Sequoyah Nuclear Plant, Unit 1 and 2
Facility Operating License Nos. DPR-77 and DPR-79
NRC Docket Nos. 50-327 and 50-328

Subject: **SEQUOYAH NUCLEAR PLANT- REVISION TO THE REACTOR
PRESSURE VESSEL SURVEILLANCE CAPSULE WITHDRAWAL
SCHEDULE FOR LICENSE RENEWAL**

Request for Revision to Reactor Vessel Material Surveillance Capsule Withdrawal Schedule for Sequoyah Nuclear Plant Unit 1

Figure 5.4.3-3 Surveillance Capsule Plan View

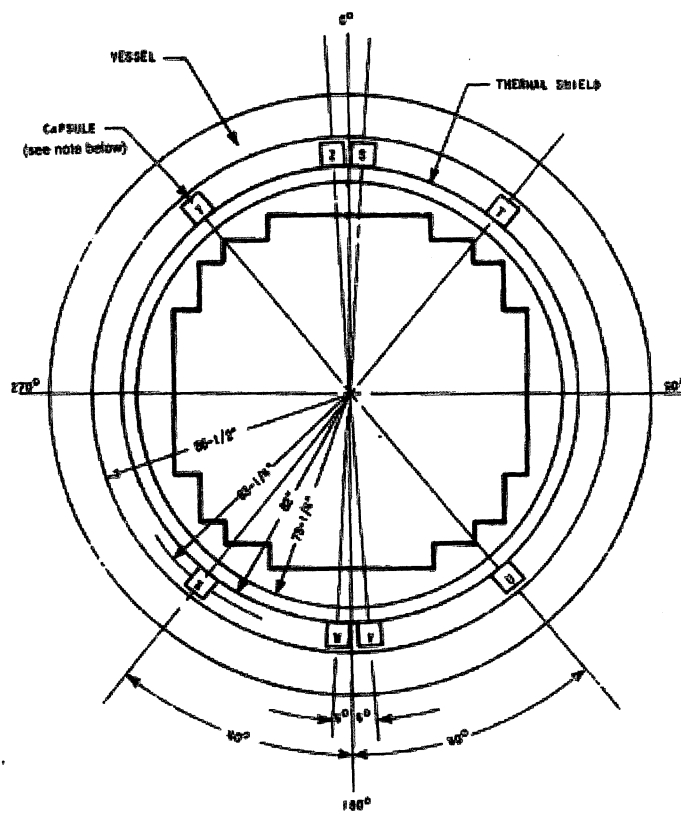
Relocation of Unit 1 reactor vessel surveillance Capsule V from the 176-degree azimuthal location to the 140-degree azimuthal location, a higher fluence location is required to support the proposed alternative capsule withdrawal schedule.

TVA is planning to relocate Capsule V in Unit 1 EOC 21, 22 or 23. The proposed revised Unit 1 schedule is to withdraw the relocated Unit 1 Capsule V (140-degree location after relocation from location 176-degree) during the EOC 31 (see FSAR Figure 5.4.3-3 below for location azimuths).

In summary, TVA is planning to relocate the Unit 1 Capsule V from the current 176-degree azimuthal location to the 140-degree azimuthal location at either EOC 21, 22 or 23. TVA is proposing a revised Unit 1 Capsule V withdrawal schedule to support the application for a SQN Unit 1 renewed license. The proposed revised schedule is to withdraw the relocated Unit 1 Capsule V during the EOC 31 outage. The remaining Capsule Z in Unit 1 will remain in standby.
